**To:** Members of Dublin City Council  
**From:** Dana L. McDaniel, City Manager  
**Date:** March 2, 2021  
**Initiated** Jennifer M. Rauch, AICP, Planning Director  
**By:** Zachary C. Hounshell, Planner I  
**Re:** Amended Ord. 02-21  
Rezoning approximately 11.37 acres from R, Rural district to PUD, Planned Unit Development district for development of 30 single-family lots with 2.62 acres of open space, located at the southeast corner of the intersection of Shier Rings and Cosgray Roads the provisions of Zoning Code Section 153.050 (Case #20-092Z/PDP).

**REZONING APPROXIMATELY 11.37 ACRES FROM R, RURAL DISTRICT TO PUD, PLANNED UNIT DEVELOPMENT DISTRICT FOR DEVELOPMENT OF 30 SINGLE-FAMILY LOTS WITH 2.62 ACRES OF OPEN SPACE, LOCATED AT THE SOUTHEAST CORNER OF THE INTERSECTION OF SHIER RINGS AND COSGRAY ROADS UNDER THE PROVISIONS OF ZONING CODE SECTION 153.050 (CASE #20-092Z/PDP).**

20-092Z-PDP  
Rezoning/Preliminary Development Plan  
Ayreshire Farms  
PID: 272-000166

**Sheet Title**  
**Conceptual  
Building  
Frontage  
Calculations**

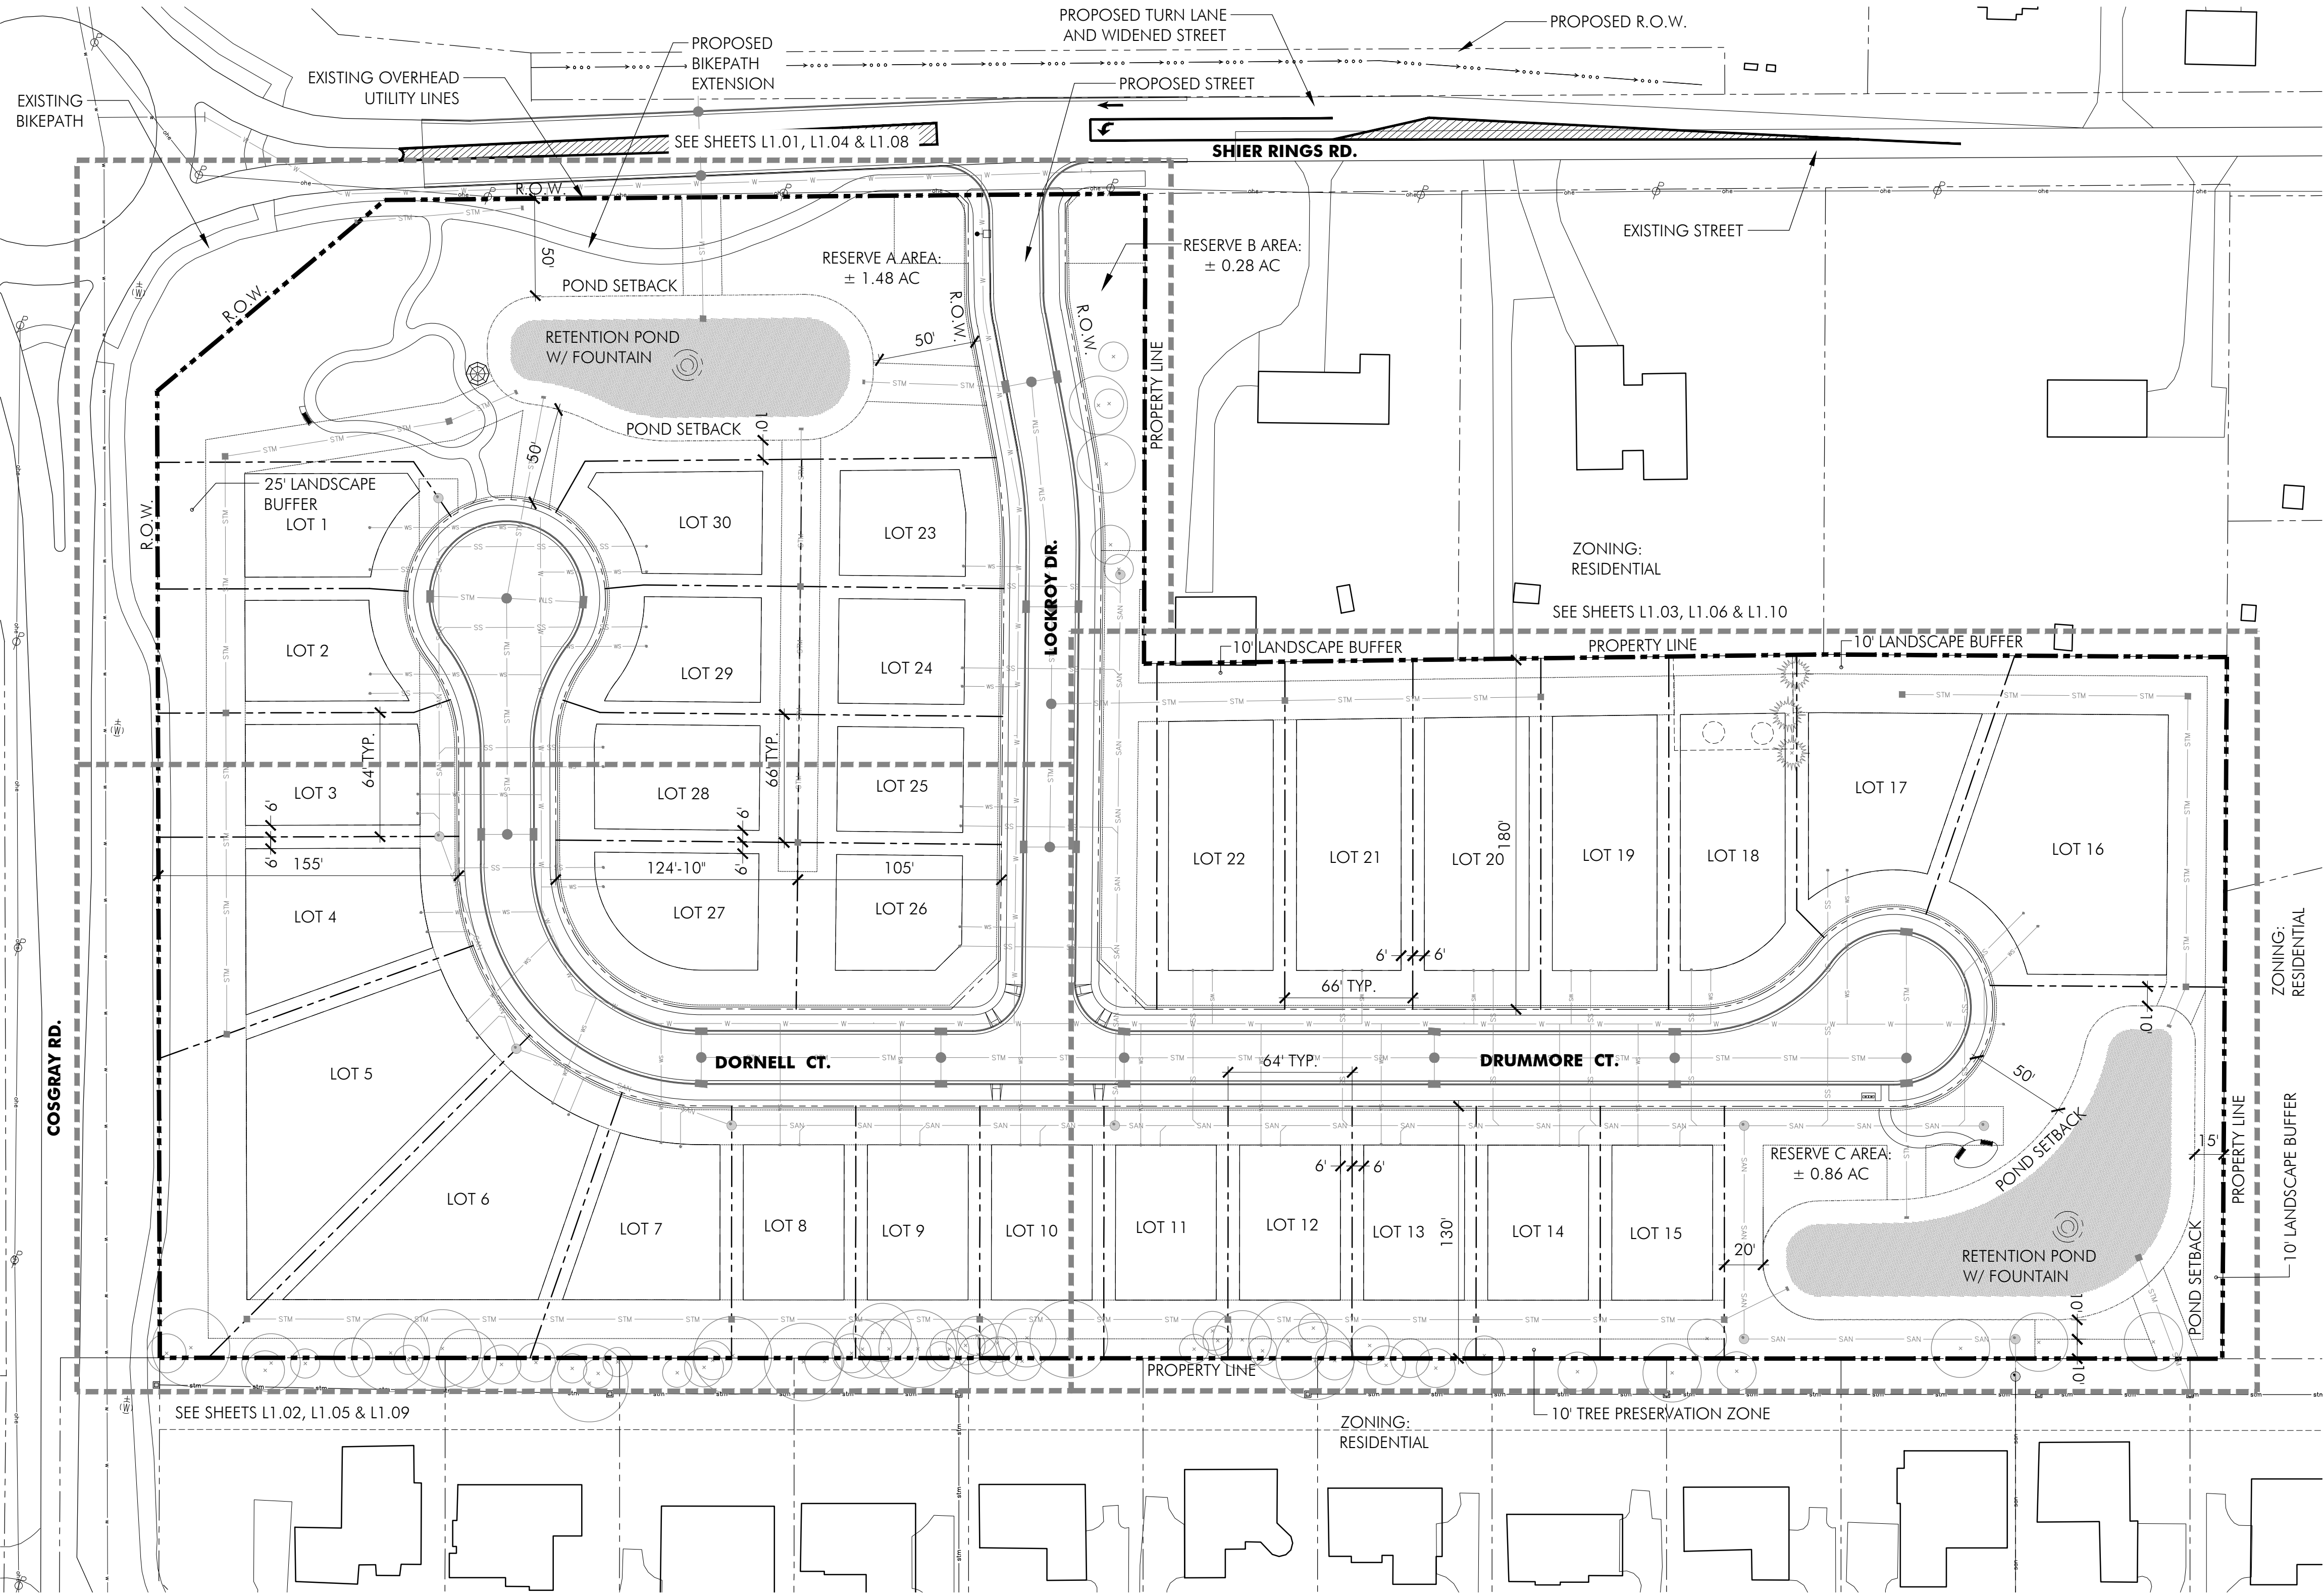
- Section G(3)(e) is updated to clarify the calculation of garage openings, stating that the opening widths of garage doors (excluding any posts or areas between the garage doors) may occupy no more than 48 percent of the front elevation, or alternatively 64 percent of the front elevation when including the posts and all areas around the garage doors (Page 6). Additionally, Exhibit L0.05 has been provided to graphically depict the

garage opening calculation for each proposed front elevation.

**Sheet Title**  
**Conceptual Home Development Plan**

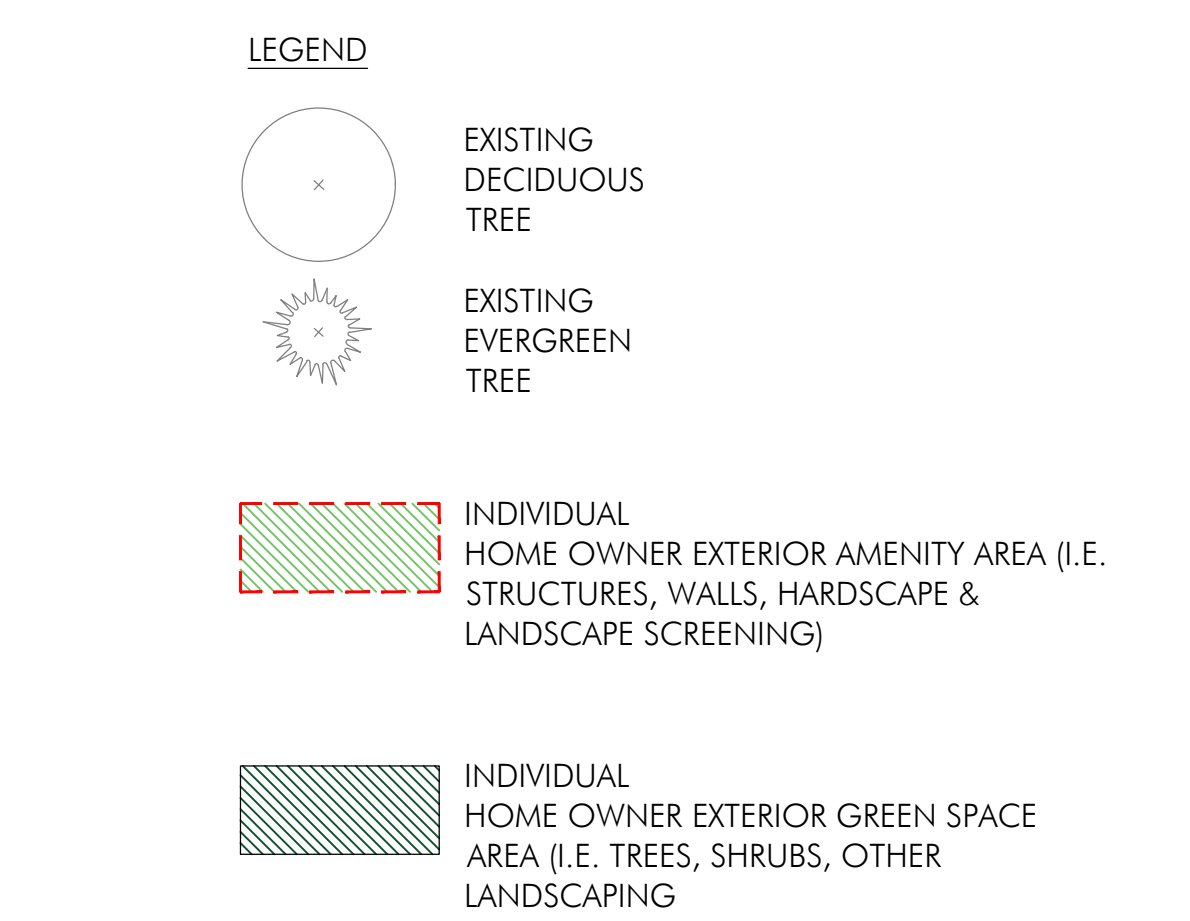
- Exhibit L2.00 has also been provided to display permissible patio areas for each lot within the development. The exhibit is required to be presented to each home purchaser to clearly identify parameters of rear yard patio areas per Section G(3)(i)(3) (Page 6).

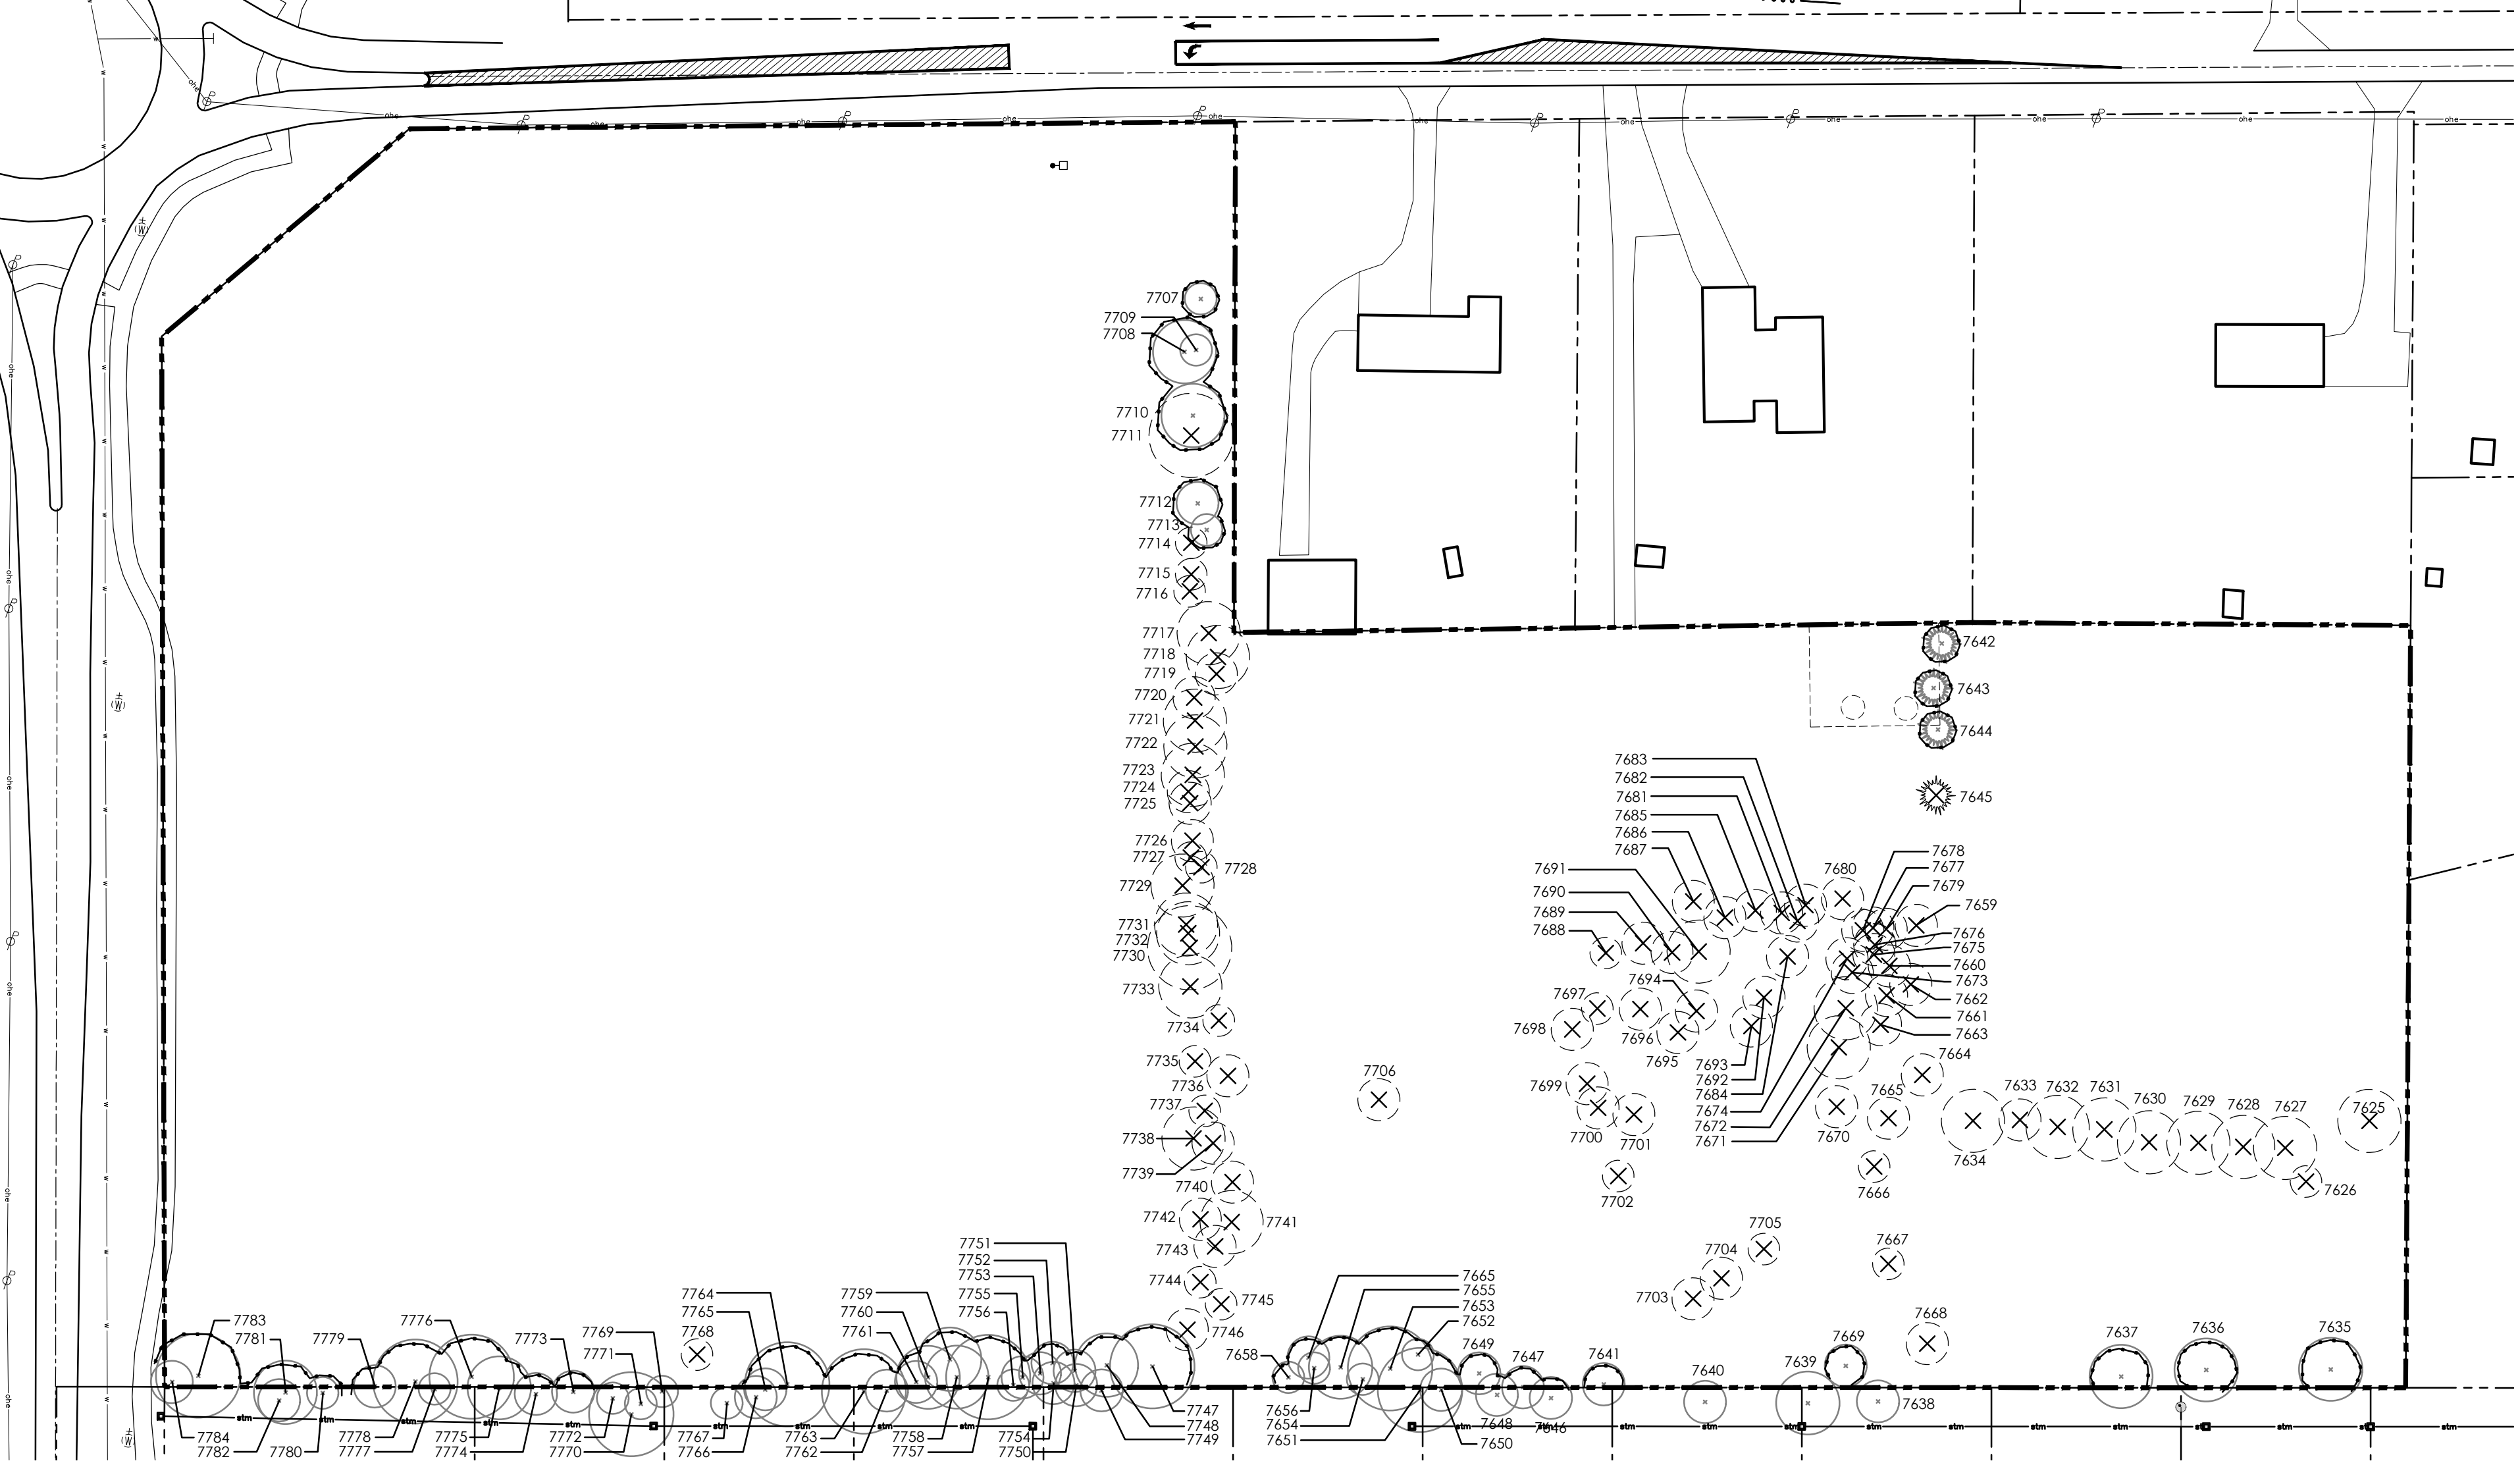
Trees are shown to be preserved east of the new entry drive. Trees #7712 and 7713 are shown to be preserved but the table inconsistently shows them to be removed. These and any other inconsistencies on the tree survey will need to be corrected prior to the Final Development Plan submittal.
